Addendum No. 2
August 24, 2022

Project: **St. Mary Catholic School Addition & Remodel**
812 N. State Avenue
Dell Rapids, South Dakota 57022
Architecture Incorporated Project #2788

Scope of this Addendum:

GROUND FLOOR PLAN - AREA A - PLUMBING & HEATING
SCALE 0 4 8 12 16

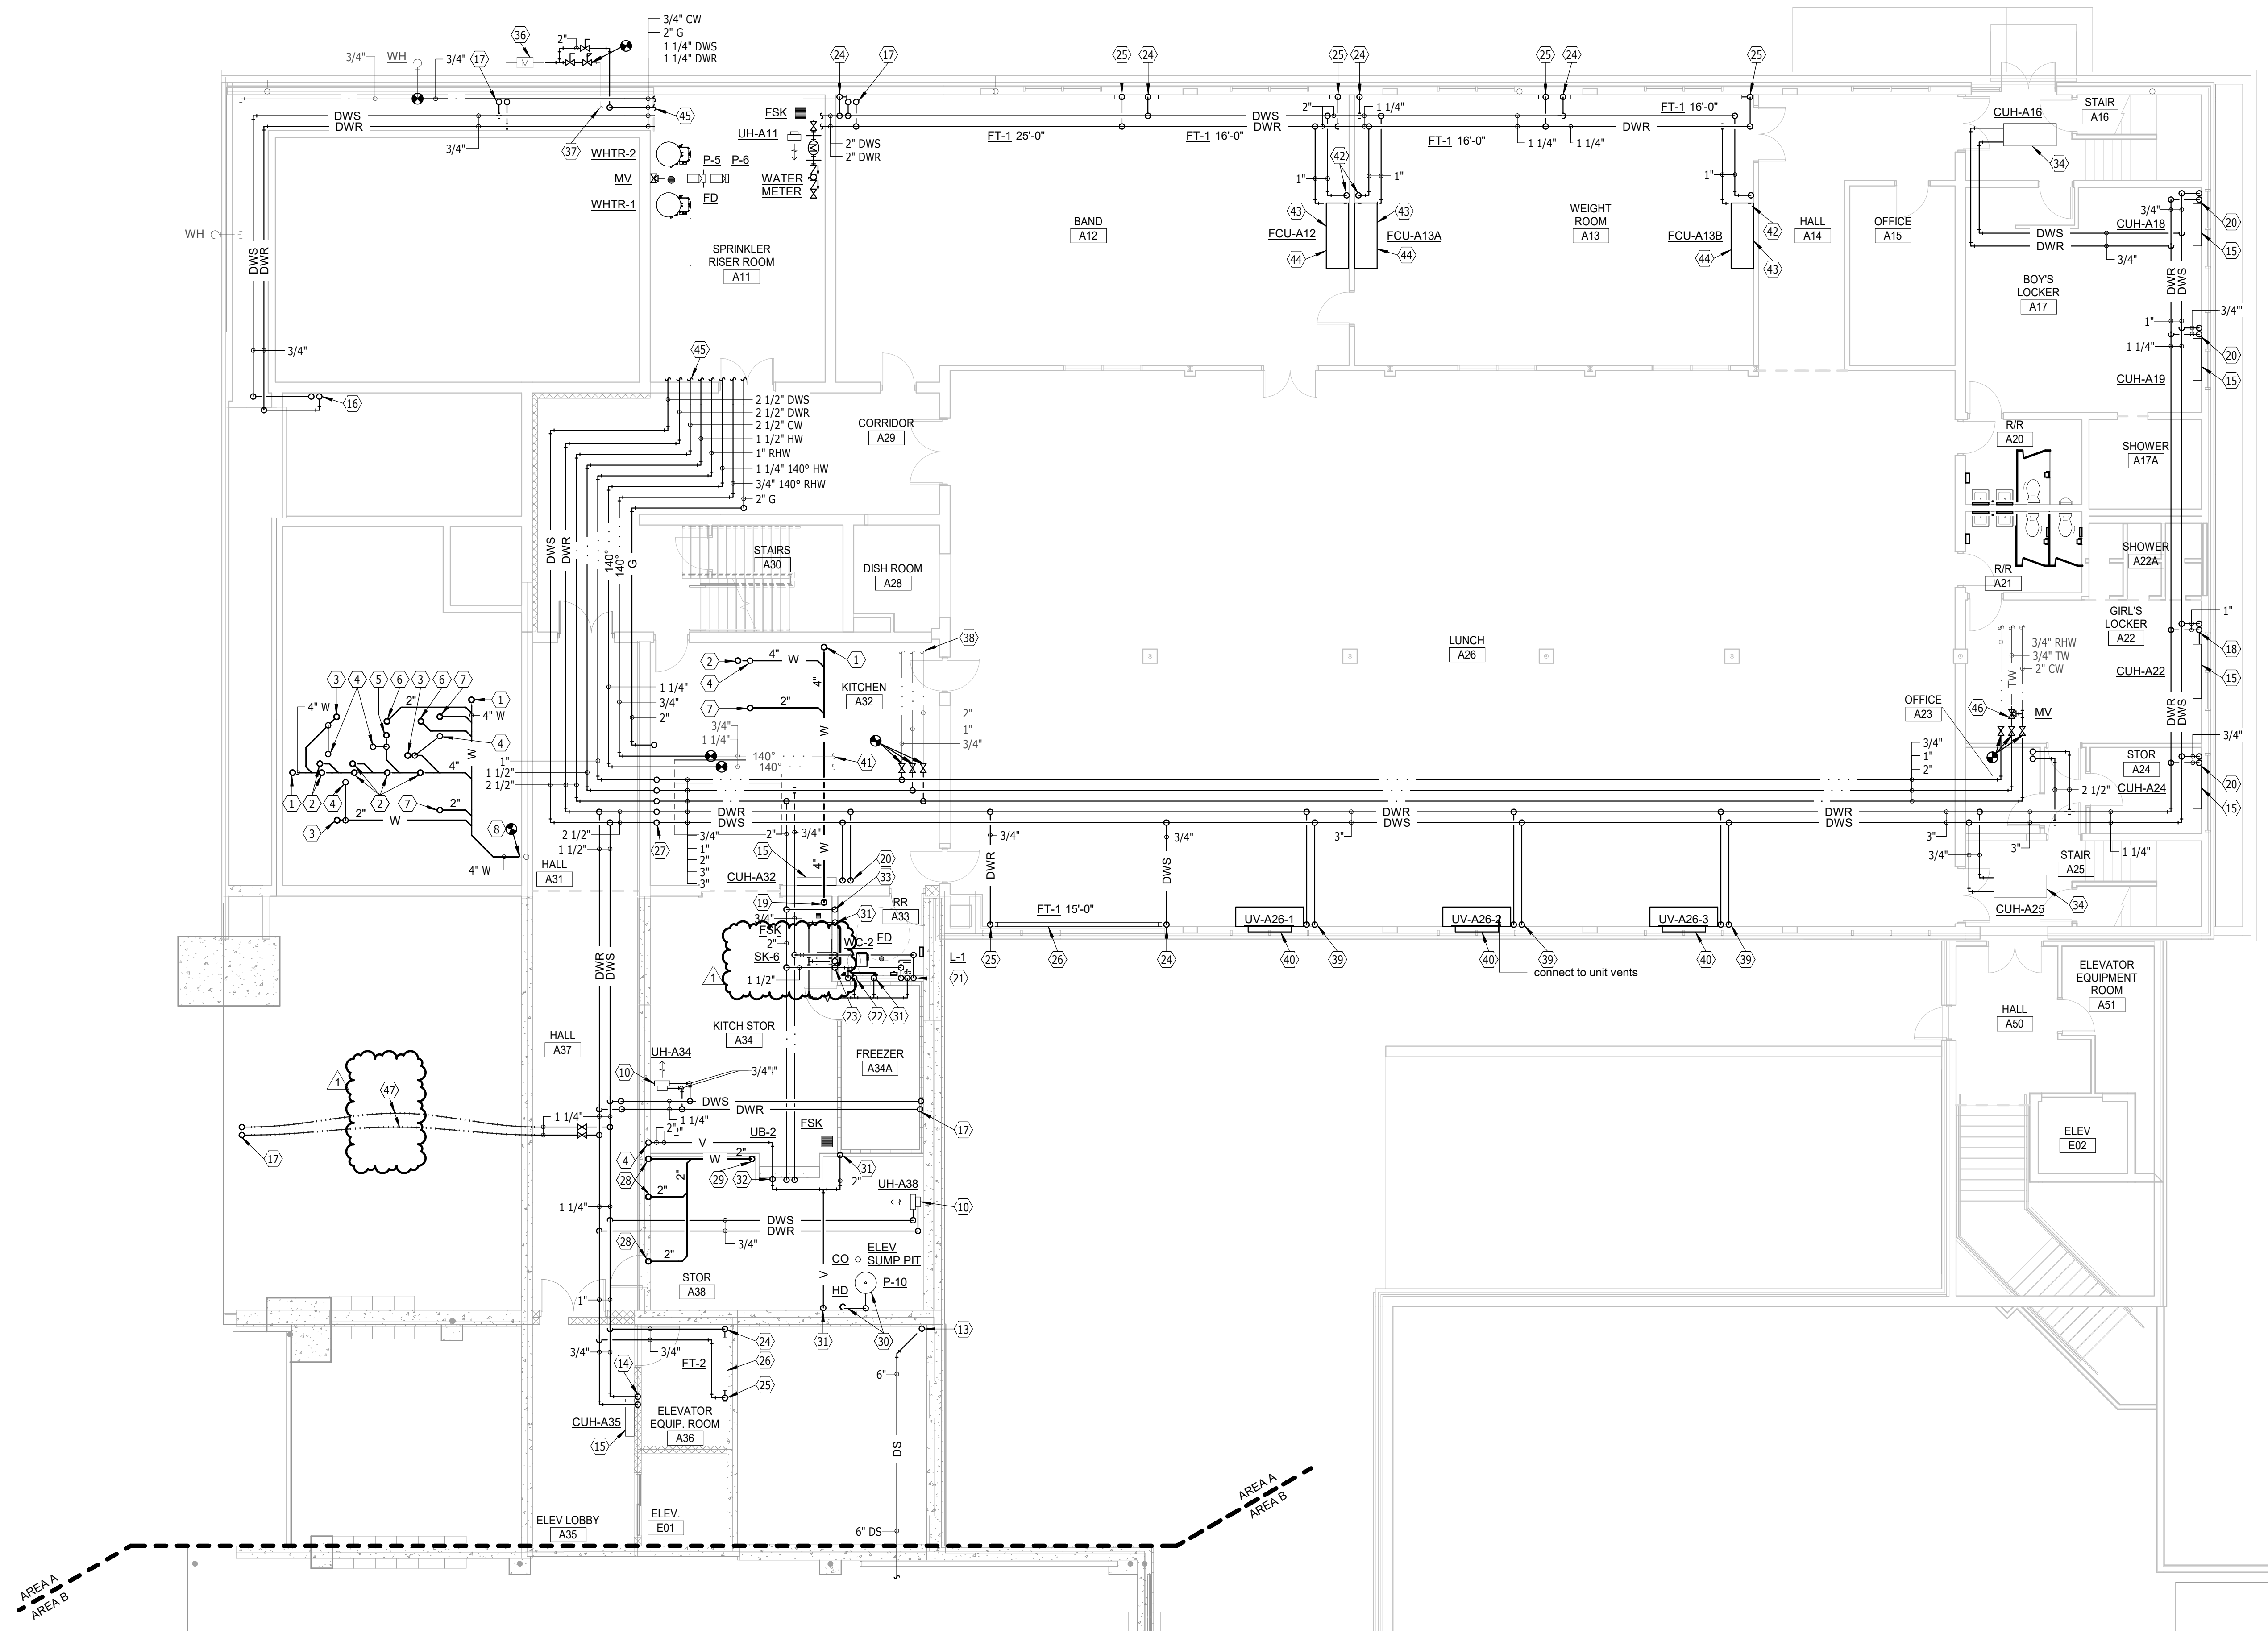
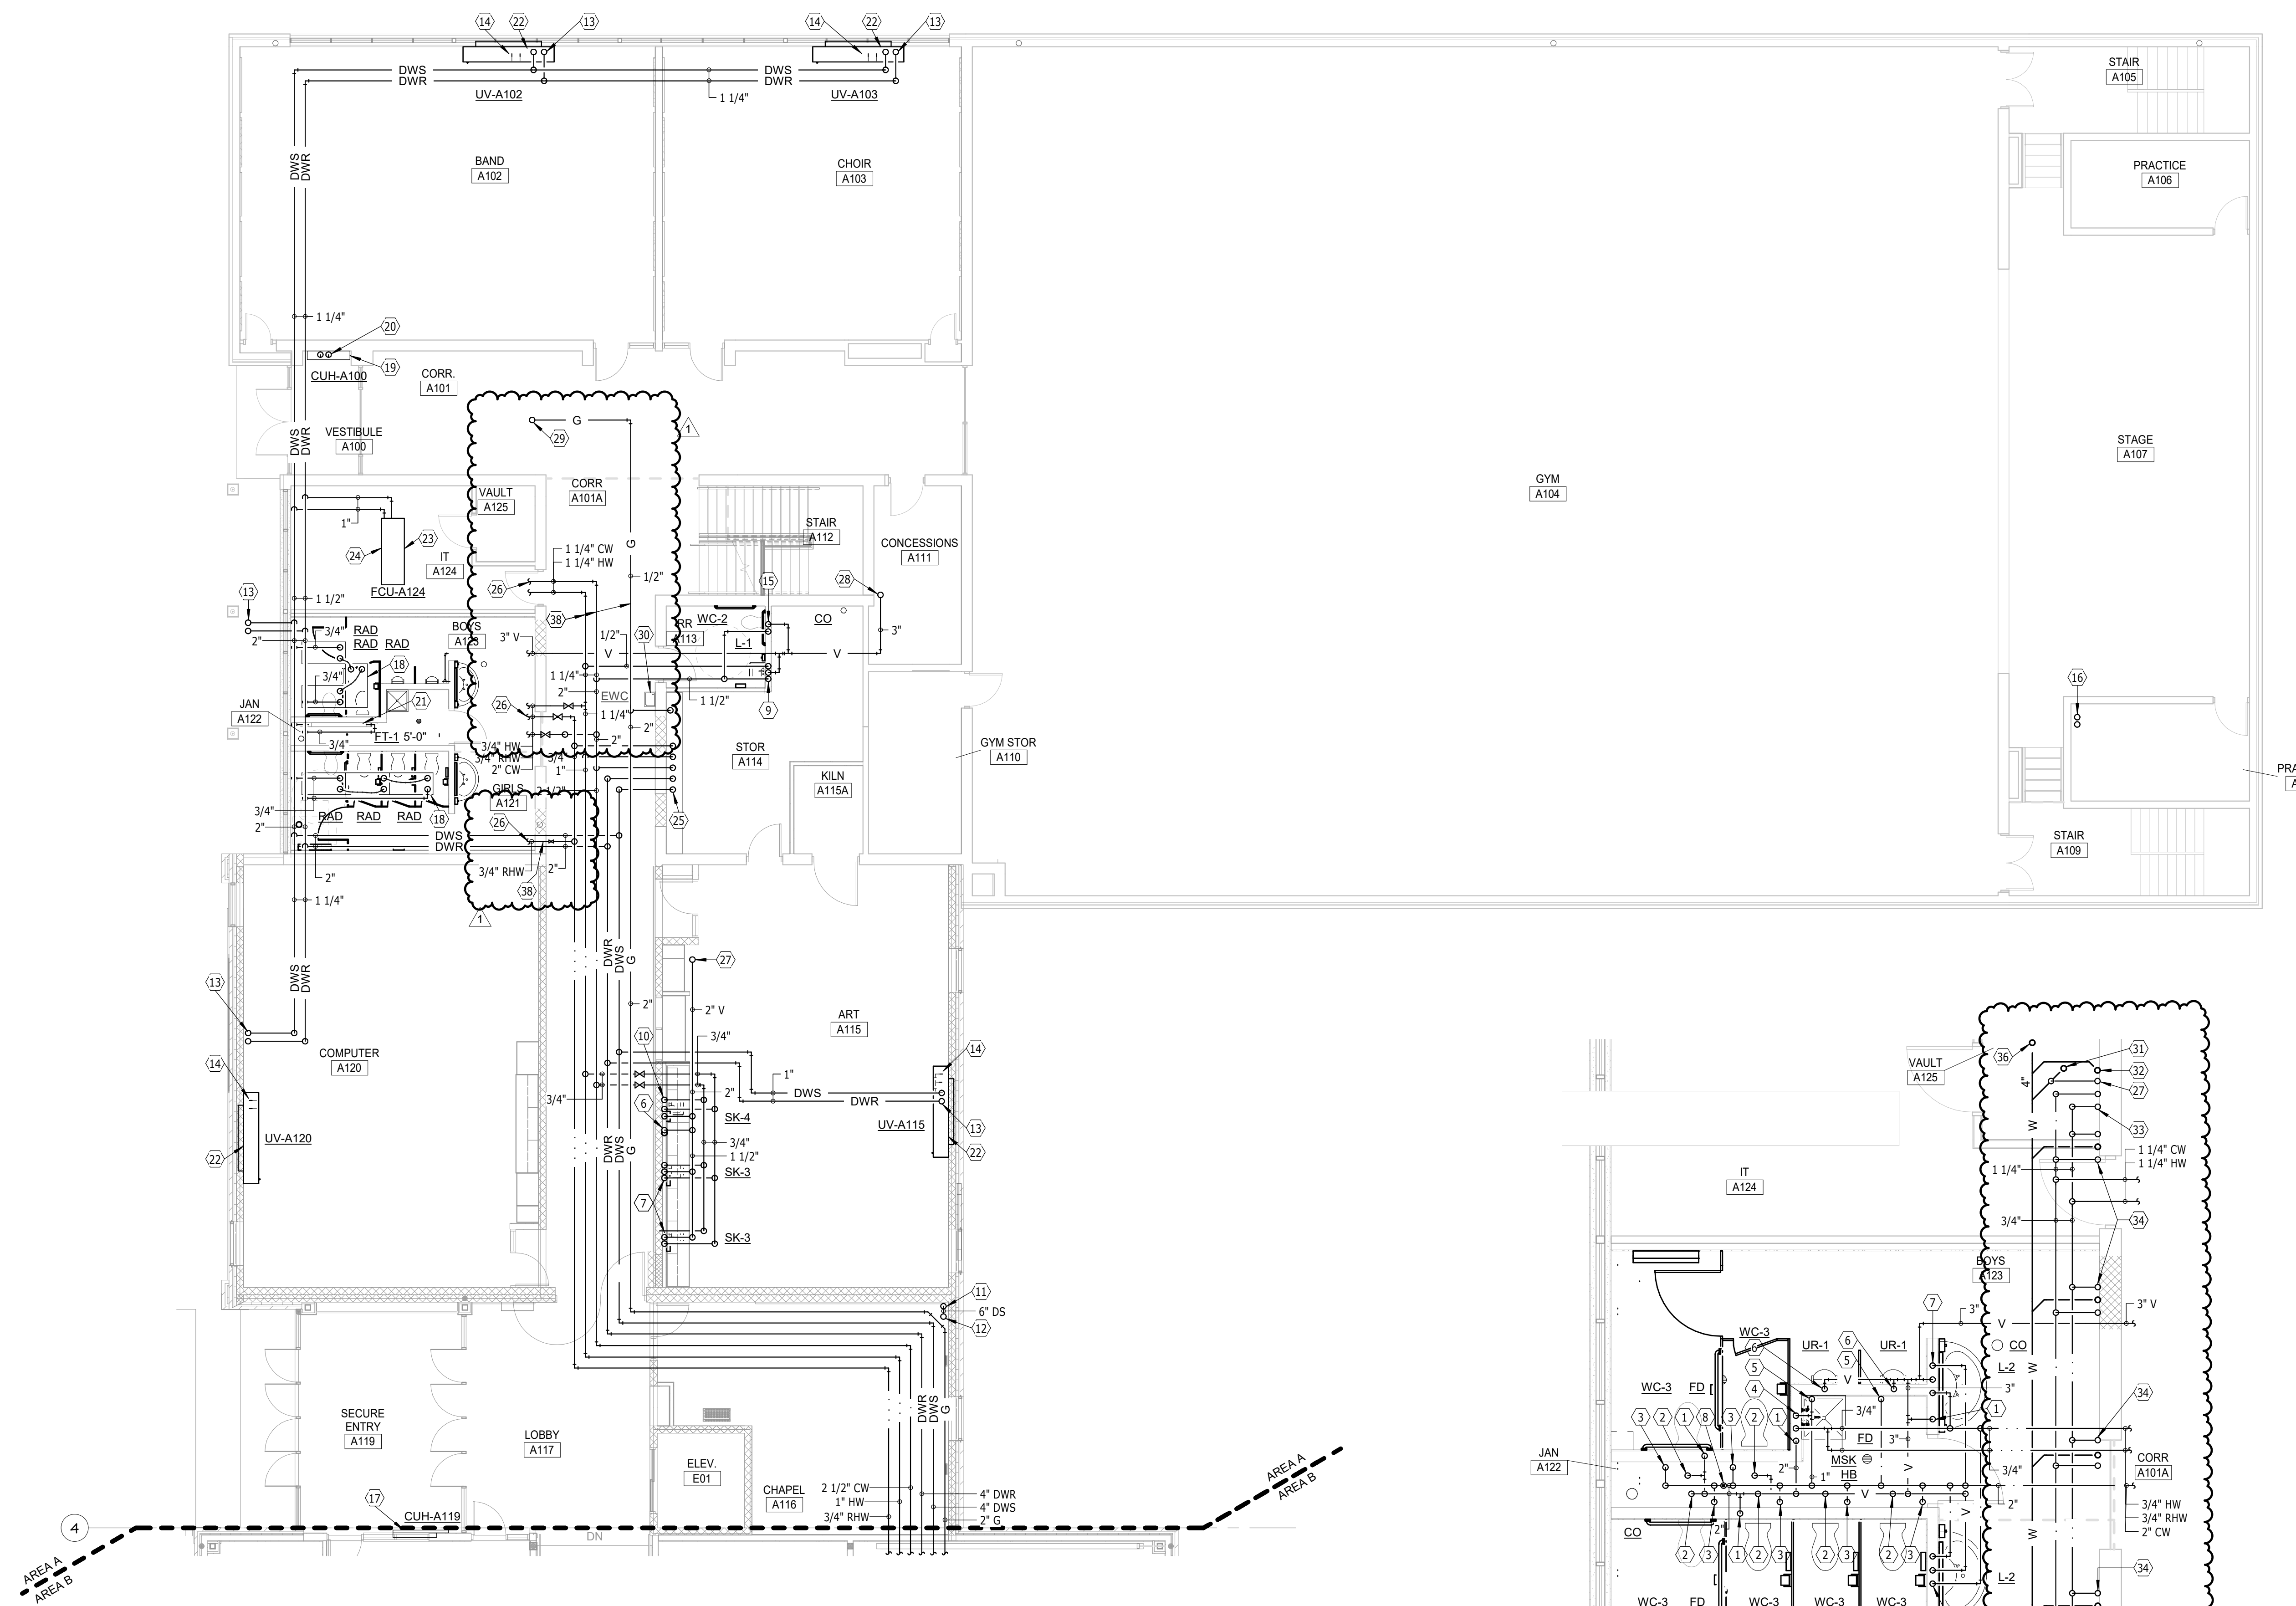
- a. KITCH STOR A34 – Add sink designation SK-6. See attached sheet.
- b. Add note #47 to flexible below floor piping. See attached sheet.
